Updated: November 2, 2021

RE: RE-ZONING AND DEVELOPMENT PERMIT APPLICATION: 1042-1044 RICHARDSON STREET

PLANNING STAFF REVIEW: APRIL 18, 2021

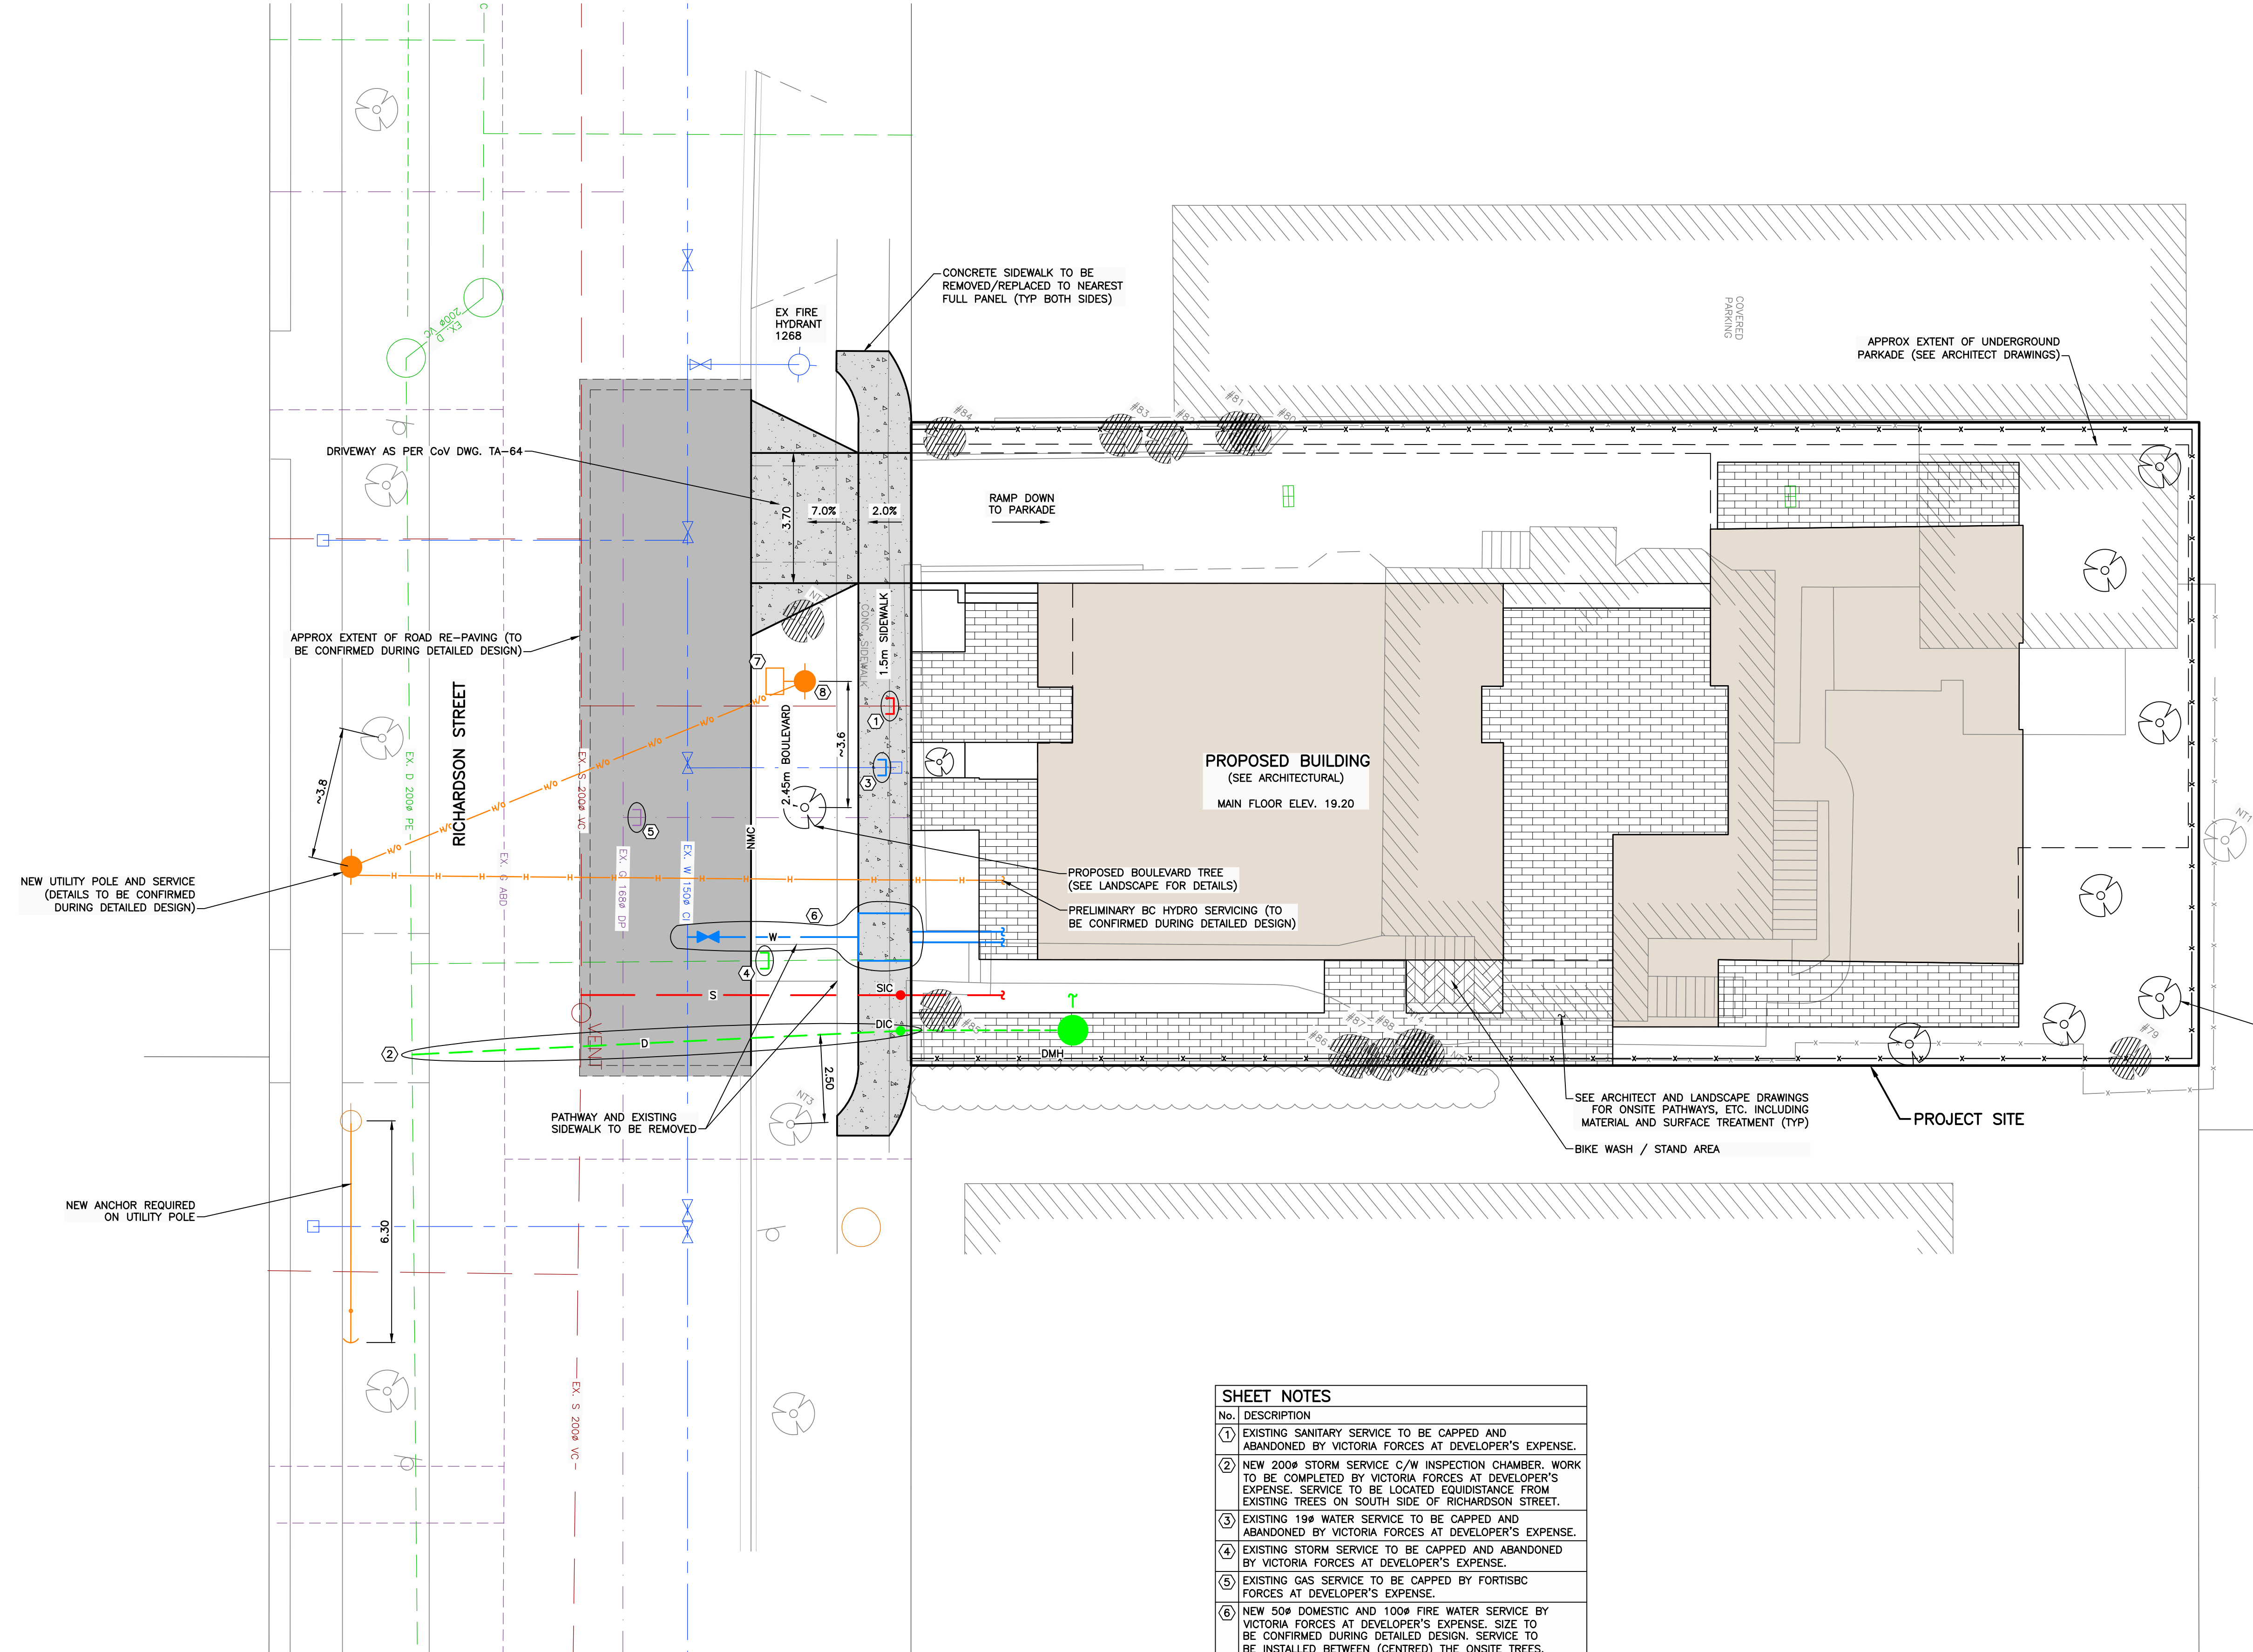
Condition #5: *The Conceptual Servicing Drawing indicates that power will be supplied from a new pole across the street. Therefore, it appears that a BC Hydro Pad Mounted Transformer (PMT) will not be required for this development. Please provide confirmation that BC Hydro has given approval for this draft*

design, and confirm if the routing is underground or overhead. Please clarify #8 under Sheet Notes on the Conceptual Servicing Drawing.

- *Please revise the building permit plan submission as follows:*
 - *show cap for the abandoned drain line at property line on the private property side*
 - *show cap for the abandoned sewer line at property line on the private property side*
 - *under Sheet Notes, change #1 and #4 to be "Abandoned storm drain and sewer services to be capped on private property by the applicant's contractor."*

Applicant Response / Actions Taken: A BC Hydro confirmed that a PMT will not be required for this development. BC Hydro has approved the design, which is included in this plan set. An overhead service is required to the new City owned pole on the north side of the road. This service provides overhead power to the charging station. An underground service is required from the BC Hydro pole on the south side of the road to the building. Clarification notes have been added to Drawing 20-083-REZONING. Additional modifications include the following:

- Drawing 20-083-REZONING has been revised to show capping on property side of service.
- Drawing 20-083-REZONING has been revised to show capping on property side of service.
- Note #1 and #4 on Drawing 20-083-REZONING have been revised.
